May 18, 2010

In Reply Refer To:  
HSSD/CC-107

This letter is in response to your request for the Federal Highway Administrations (FHWA) acceptance of a roadside safety system for use on the National Highway System (NHS).

Name of system:	Type IIA Box Beam End Terminal
Type of system:	End Terminal
Test Level:	Modified MASH TL-3
Testing conducted by:	Midwest Roadside Safety Facility
Date of request:	November 10, 2009
Date of completed package:	April 13, 2010
Request initially acknowledged:	November 19, 2009

**Enclosure 2: Summary of Test Results and Sequential Photographs, Test 3-34**

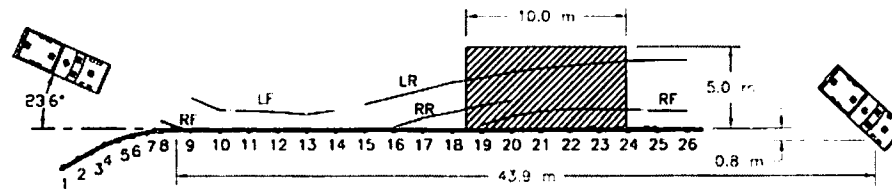
Different variations of the Type IIA end terminal were crash tested by the Midwest Roadside Safety Facility. The variation described above and shown in Enclosure 1 was crash tested according to MASH test 3-34. The test article passed the test. Enclosure 2 shows a summary of the test results.

The point of impact for Test 3-34 is the Critical Impact Point (CIP). By definition, the CIP is where the behavior of the test article changes from redirecting the impacting vehicle to either capturing the vehicle or allowing it to gate through the system. Normally the CIP is determined through detailed analysis of the end terminal or use of relevant computer programs. However, in the test conducted, the CIP was assumed and then verified by a full scale crash test.

**Enclosure 3: Summary of Test Results and Sequential Photographs, Test 3-35**

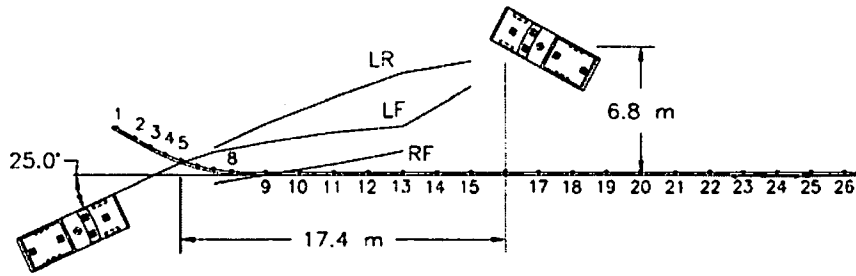
Test 3-35 was conducted on a variation of the final Type IIA End Terminal and the test article passed the test (Enclosure 3). The difference between this test article and the final Type IIA end terminal is that post 2 and 4 were moved to the back side of the rail for the final Type IIA End Terminal. This change is not expected to have a significant effect on the performance of the terminal and we concur that the final design would also be expected to pass the test.
